ADDENDUM NO. 2

September 9, 2022

CROWN POINT HIGH SCHOOL ATHLETIC FIELDS AND SITE IMPROVEMENTS
Crown Point, IN 46307

ADDENDUM TWO

SHEET
A-104

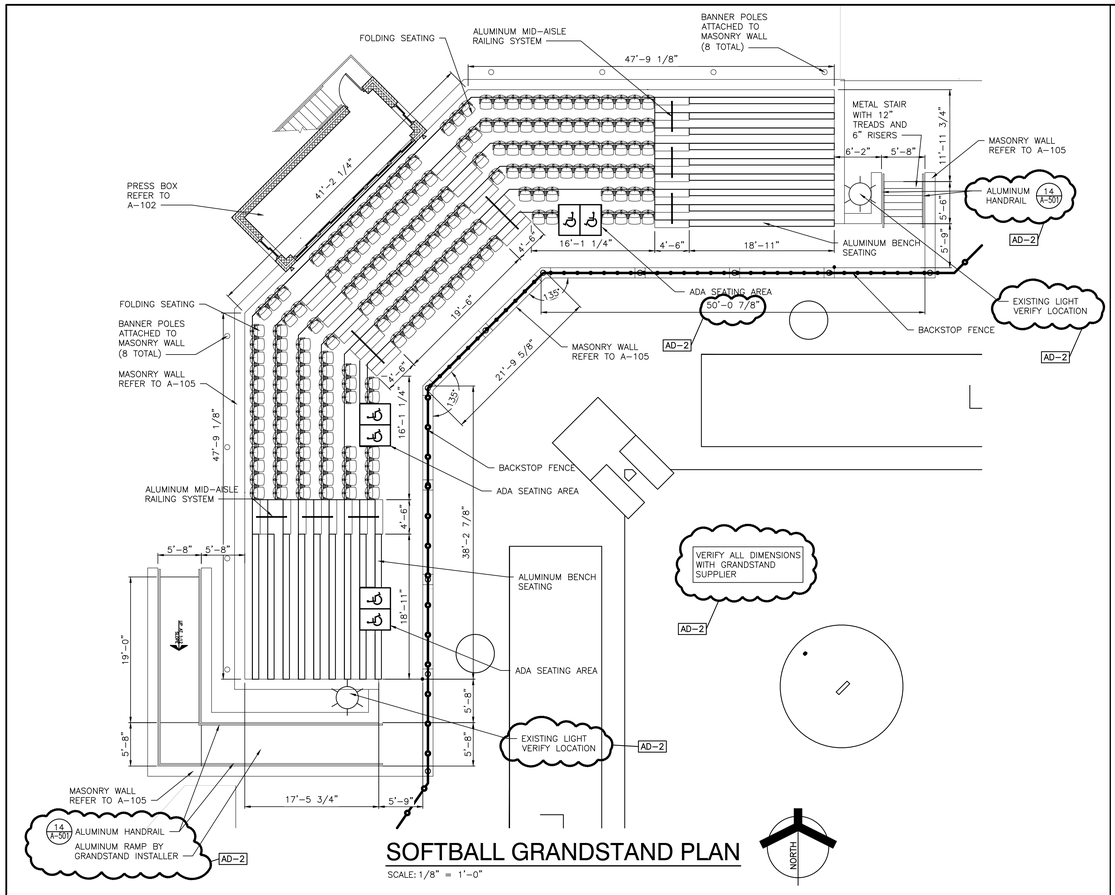
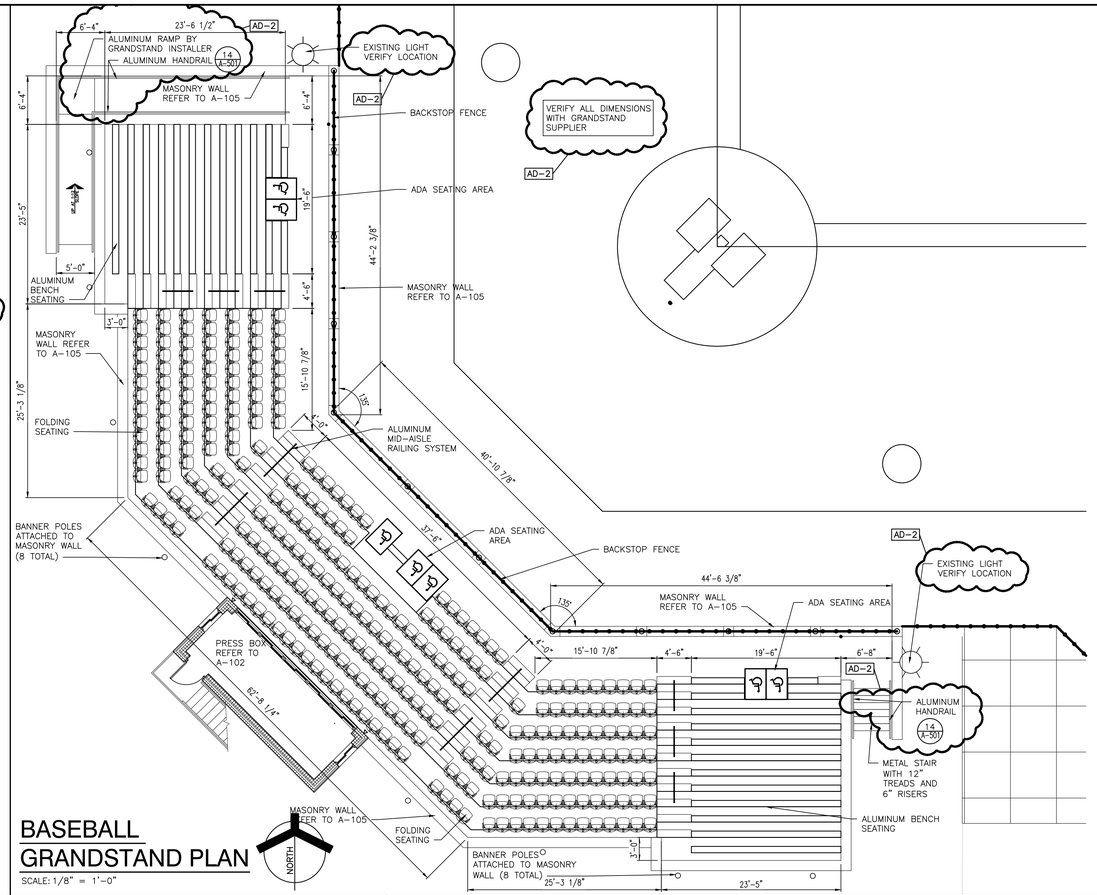
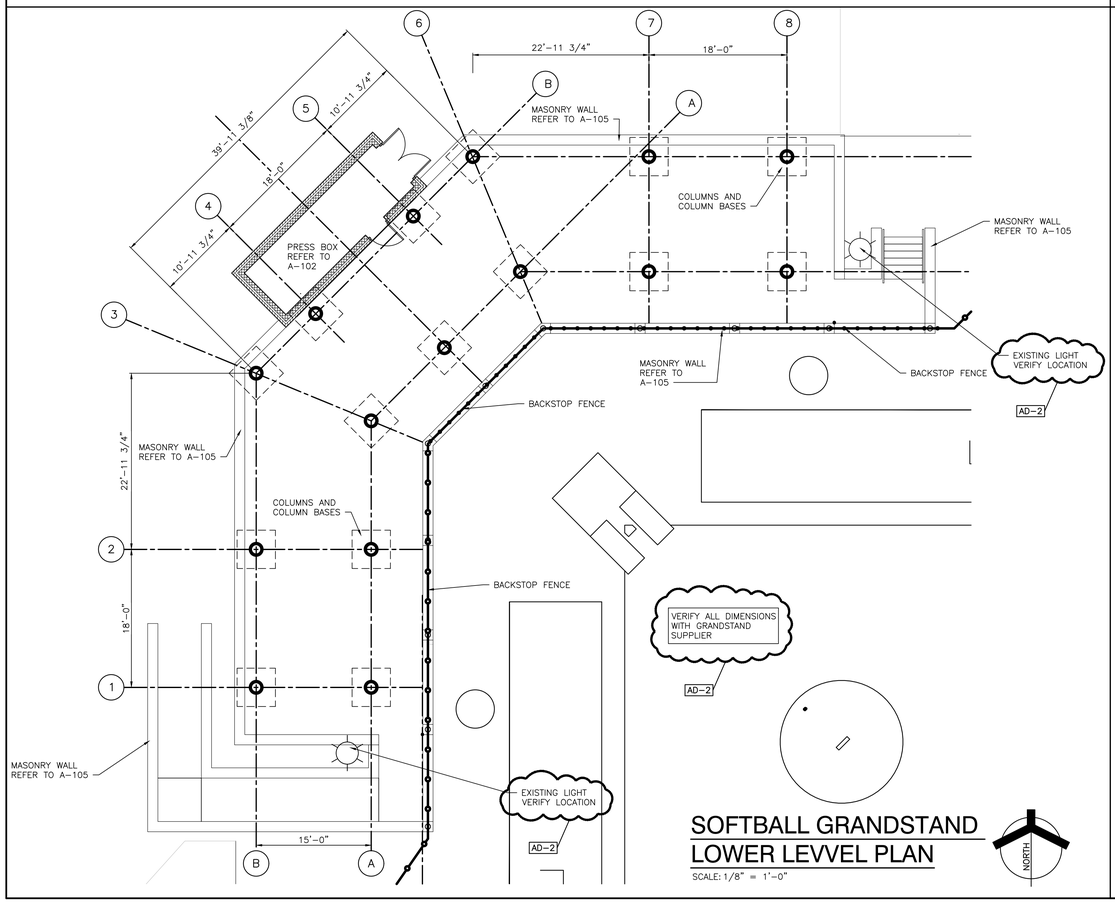
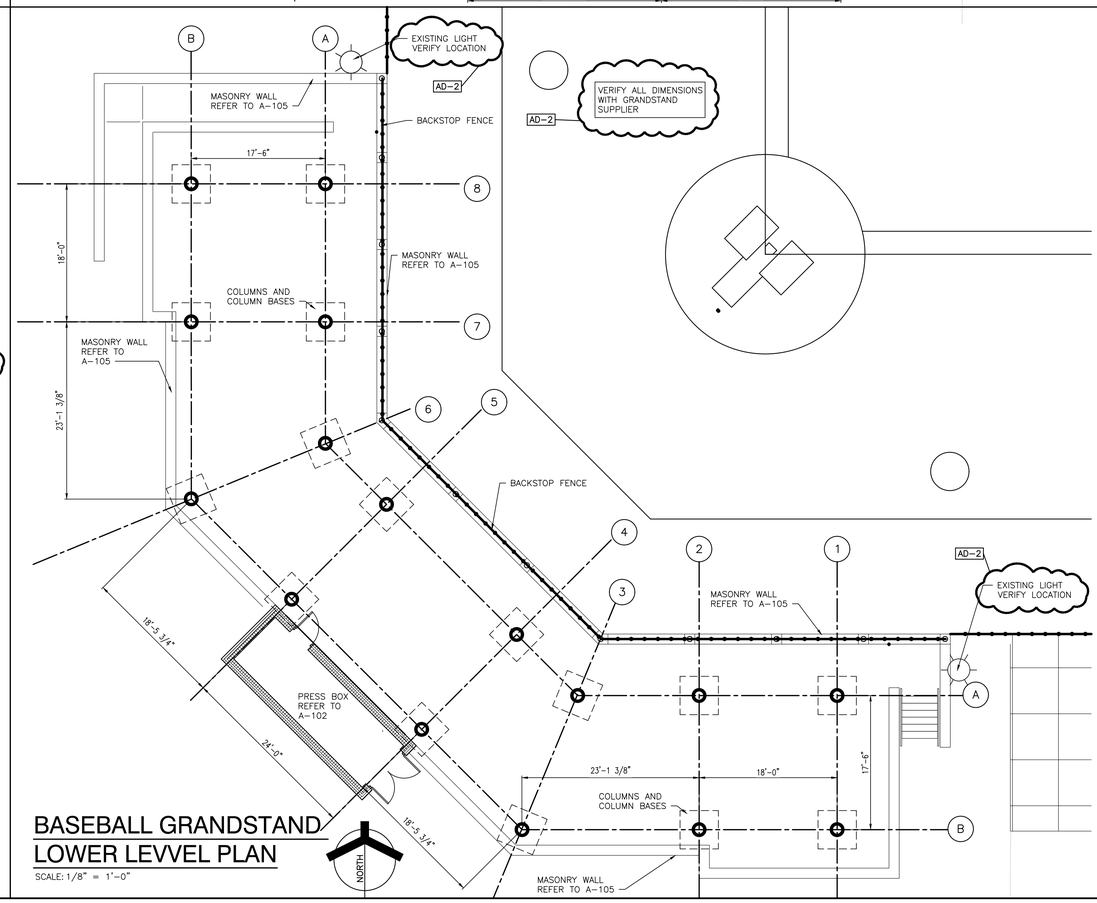
21. Sheet A-104

A. Refer to attached revised full-size drawing, included in this Addendum, for revisions.

SHEET
A-106

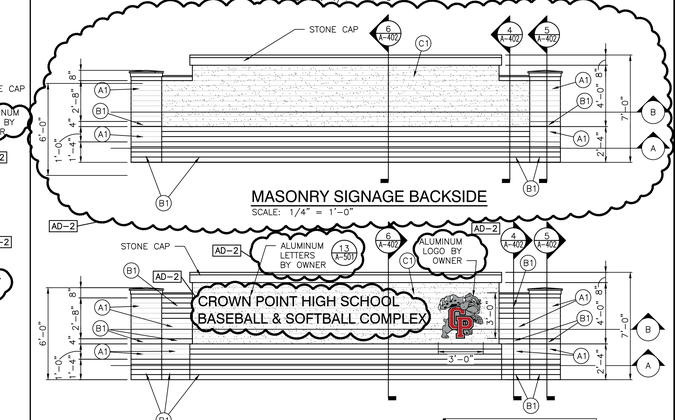
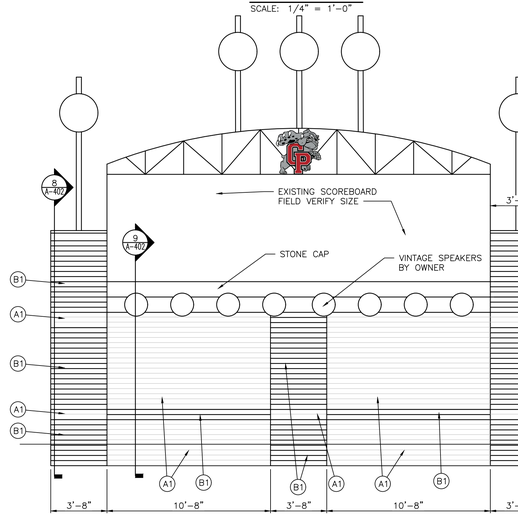
23. Sheet A-106

A. Refer to attached revised full-size drawing, included in this Addendum, for revisions.

SHEET
E-005

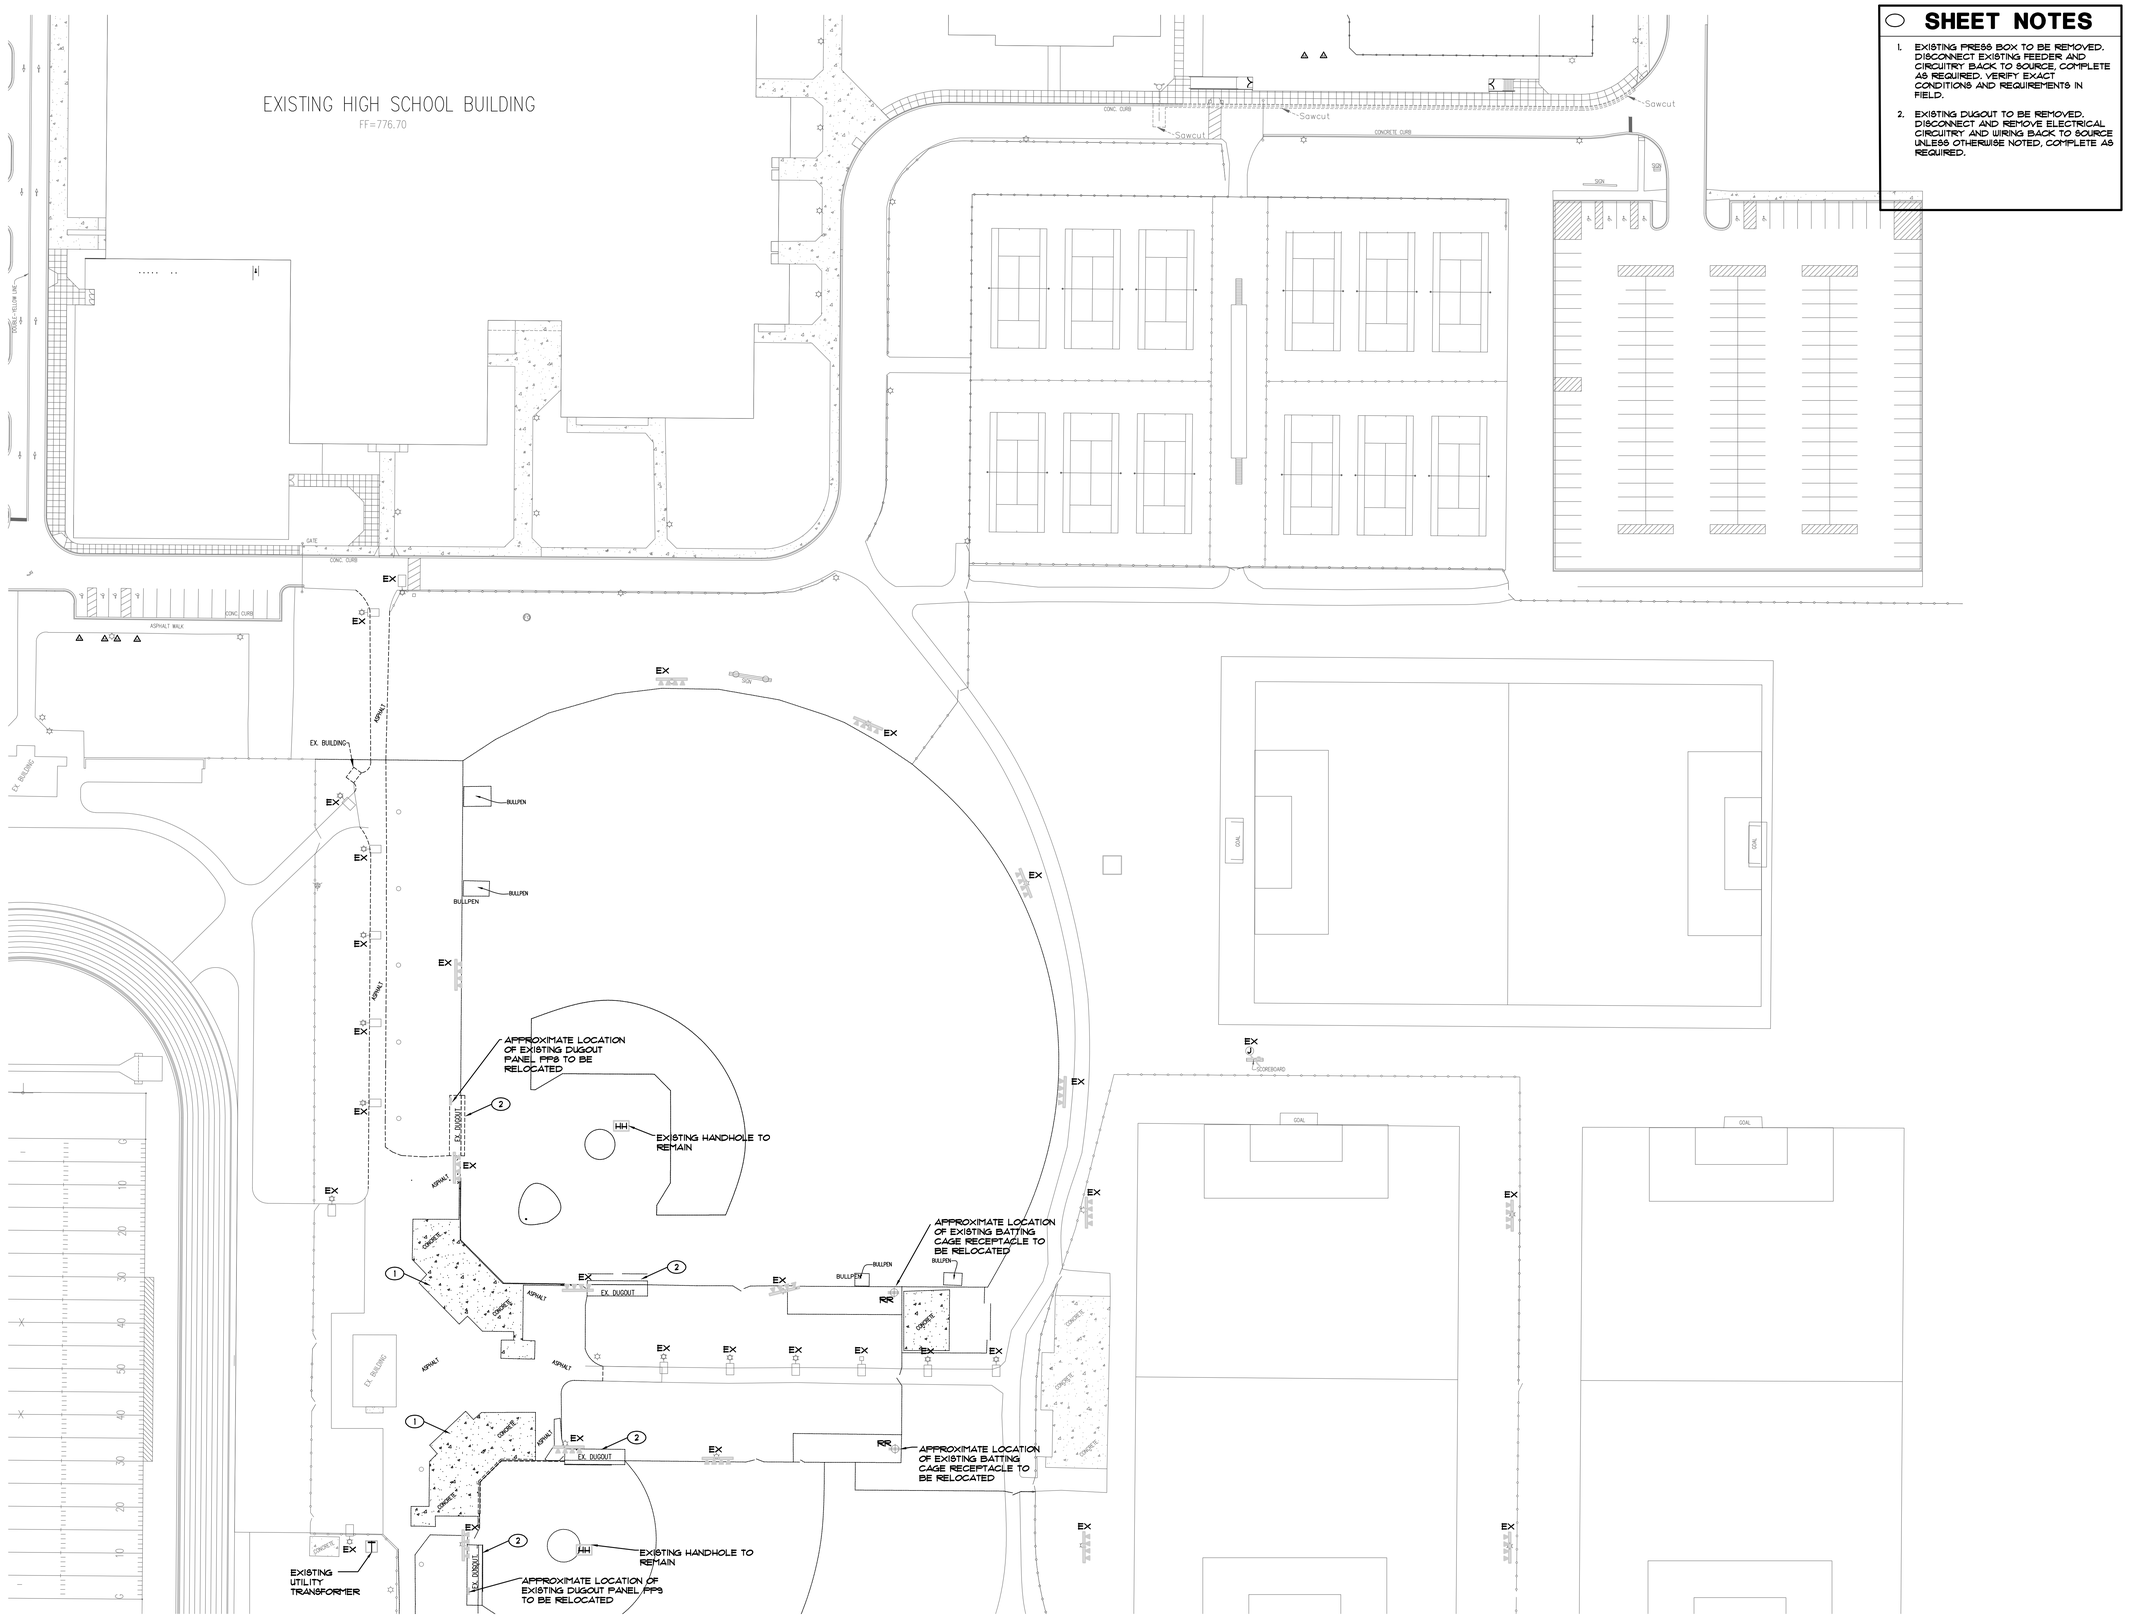
29. Sheet E-005

A. Refer to attached revised full-size drawing, included in this Addendum, for revised site lighting circuiting from Panel PP-1 to Panel HP-2.

SHEET
ES102

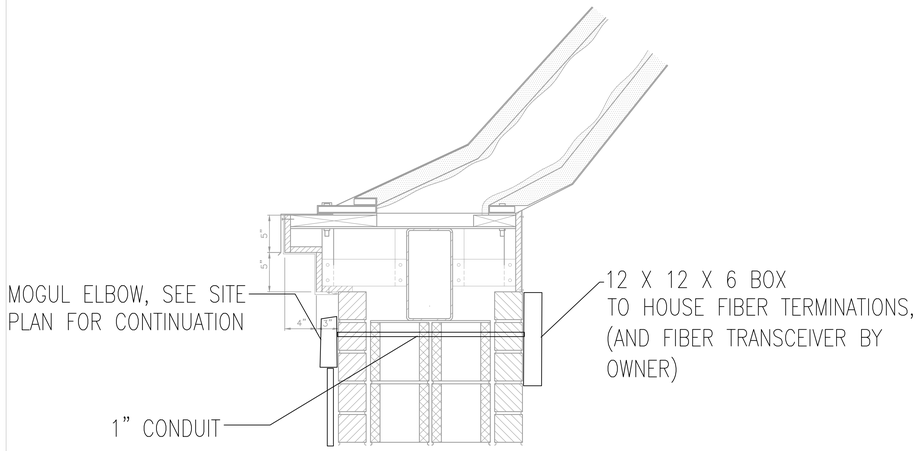
32. Sheet ES102

A. Refer to attached revised full-size drawing, included in this Addendum, for the following revisions:

1. Revised flagpole lighting location.
2. Added additional site lighting Fixture Types EC.
3. Revised circuit for site lighting Fixture Type EC.

1 TELECOMMUNICATIONS BACKBONE DIAGRAM CPHS SITE
NTS

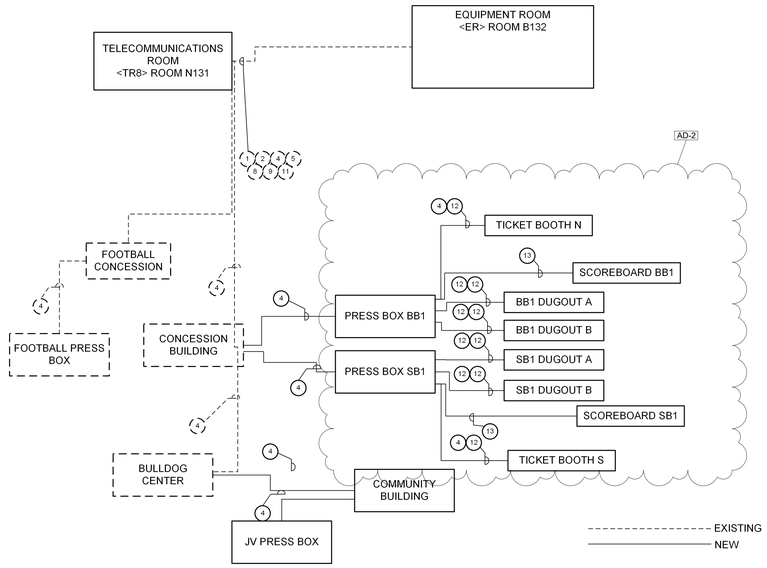
37. Sheet T-601

A. Refer to attached revised full-size drawing, included in this Addendum, for updated backbone to ticket booth locations.
